**CITY OF MERIDIAN
FINDINGS OF FACT, CONCLUSIONS OF LAW
AND DECISION & ORDER**

Case No(s). H-2025-0048

COMMUNITY DEVELOPMENT DEPARTMENT REPORT

SUBJECT: Blueberry Hills Subdivision – AZ, PP
H-2025-0048

Blueberry Hills
Subdivision
Plat Layout

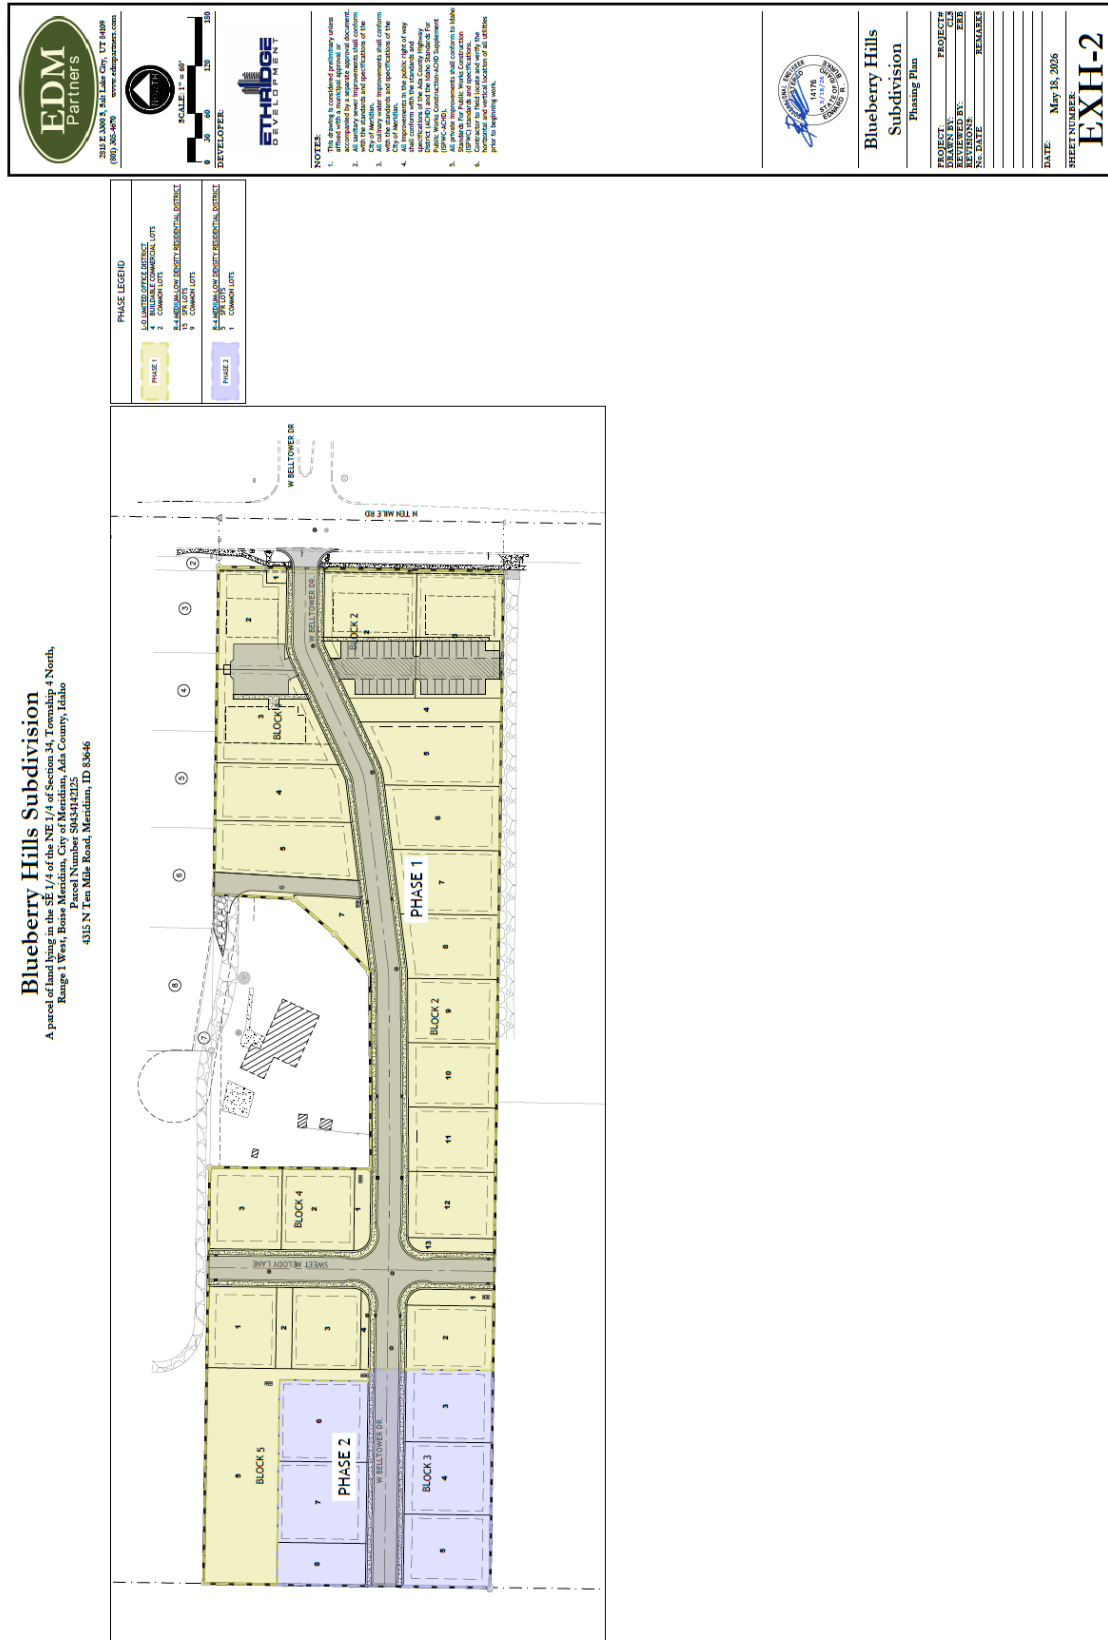
2. The final plat(s) shall include the following revisions:
- i. Include a minimum 15' wide common area along the east side of Lot 6, Block 5 in order to provide the minimum 5' wide landscape strips required along each side of the 5' wide pathway.

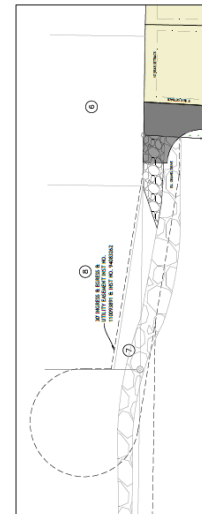
The driveway shall be located on east side of lot per UDC 11-6C-3D.5

J. Qualified Open Space Exhibit (date: 5/19/2026)

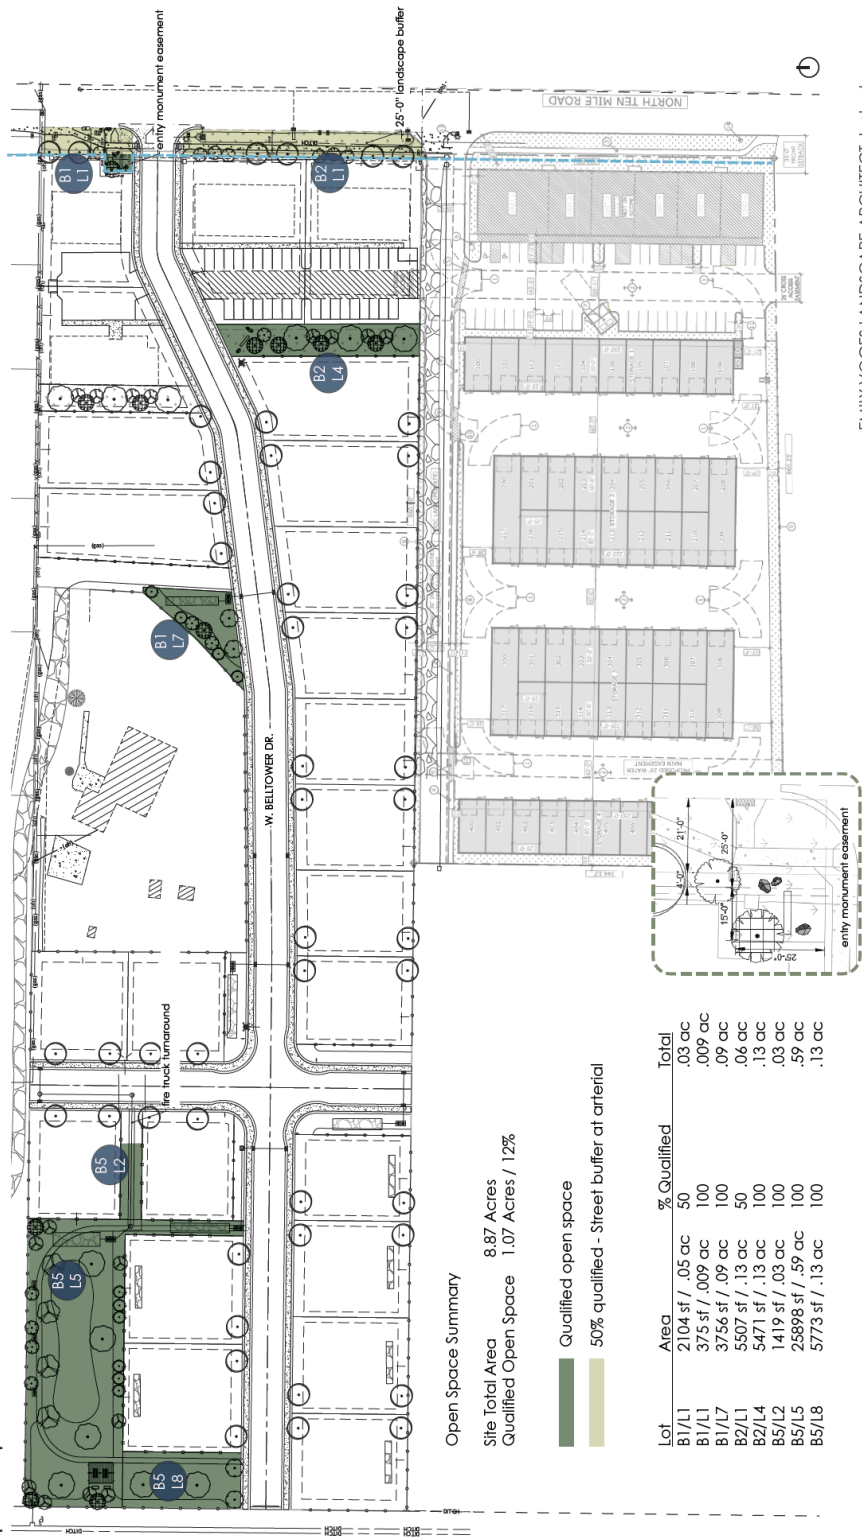
3. The landscape plan submitted with the final plat application(s) shall include the following revisions:
- i. Include a detail of the picnic area, which includes tables, benches, landscaping and a structure for shade in accord with UDC 11-3G-3C.5.

- iii. Include a minimum 15' wide common area along the east side of Lot 6, Block 5 in order to provide minimum 5' wide landscape strips along each side of the pathway as required.
